44474A-01A

S E R V I C E N O T E

April 28, 2008

Defective connectors shipped with 44470A, 44471A, 44473A, 44474A

Figure 2: Good Connector with alternating pins on top and bottom

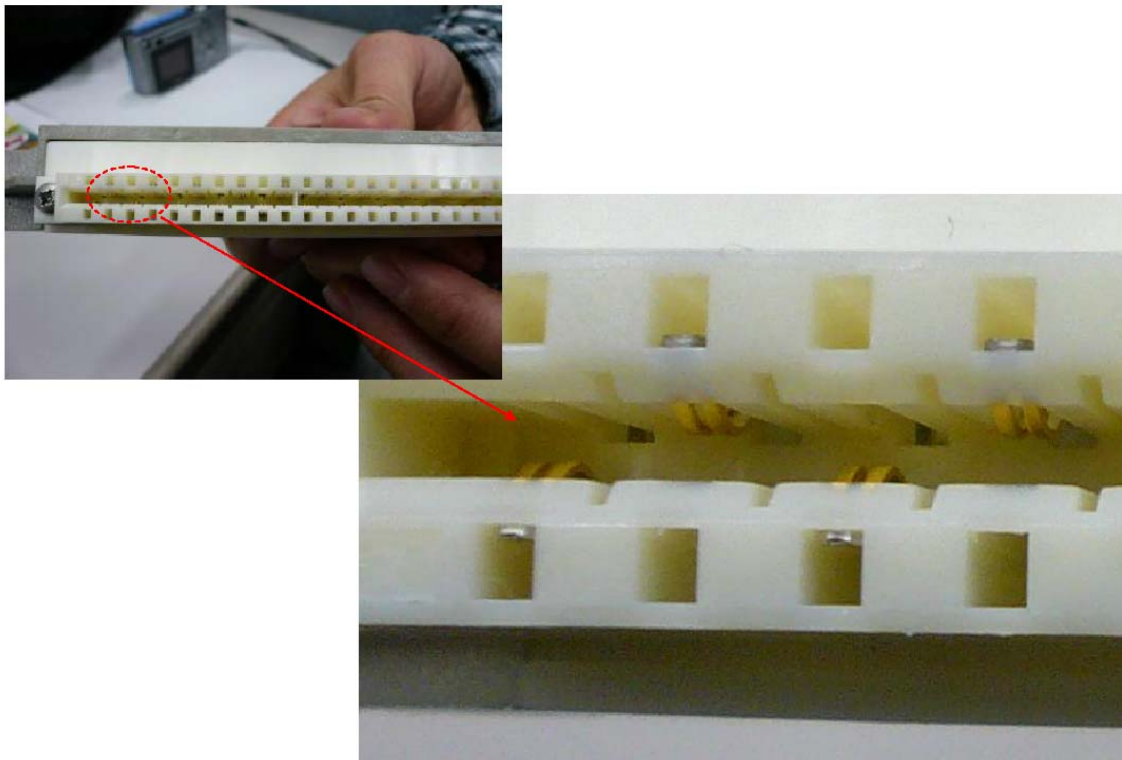
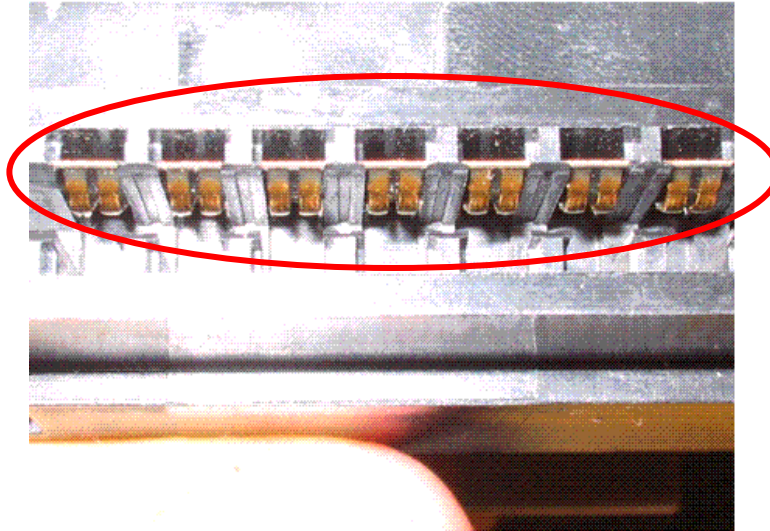
The 44470A, 44471A, 44473A, and 44474A products consist of a main relay plug in module and a removable terminal block (see Figure 1). These are plug in modules for the card cage mainframes 3488A, 3499A, 3499B, and 3499C. The main relay card contains the serial number. The removable terminal module does not contain a serial number. It is possible that over time a terminal block will no longer be used with the same serialized relay card that it was shipped with. A visual inspection of the connector in the removable terminal block is necessary to determine if a defective connector is present. The visual inspection should override the serial number range limits. All white colored connectors are good and have pins that alternate top to bottom (see Figure 2). A black colored connector is bad if it contains all pins on one side of the connector (see Figure 3). A black colored connector is good if it contain pins that alternate top to bottom (not pictured).

The procedure to correct the defective connectors is very simple. One must replace the defective connector with a good connector (see connector part numbers list on page 2). The customer may perform this procedure or have an Agilent-qualified person perform this procedure.

Figure 4: Removing defective connector from terminal block

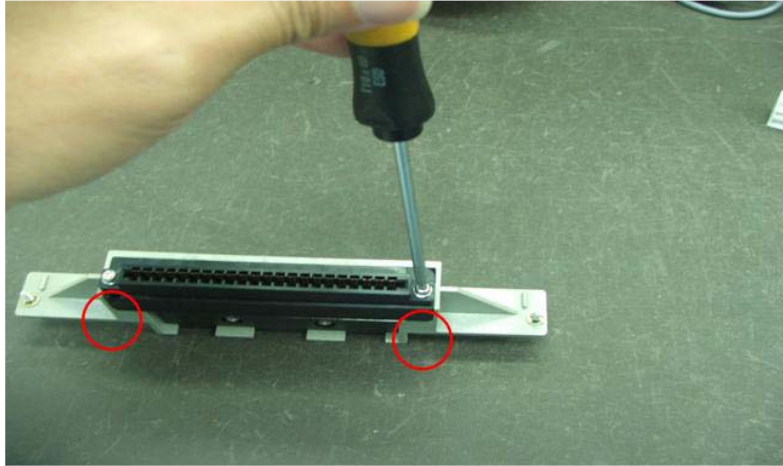
Connector Replacement Procedure: After identifying a defective connector, the connector in the terminal block is repaired by removing the two screws that hold the connector to its case. Note the orientation of the connector. This will release the connector from the terminal block and then a good one can replace it. No soldering is necessary. See Figure 4.

1. Use a T10 torx driver to unscrew the 2 screws of the connector.
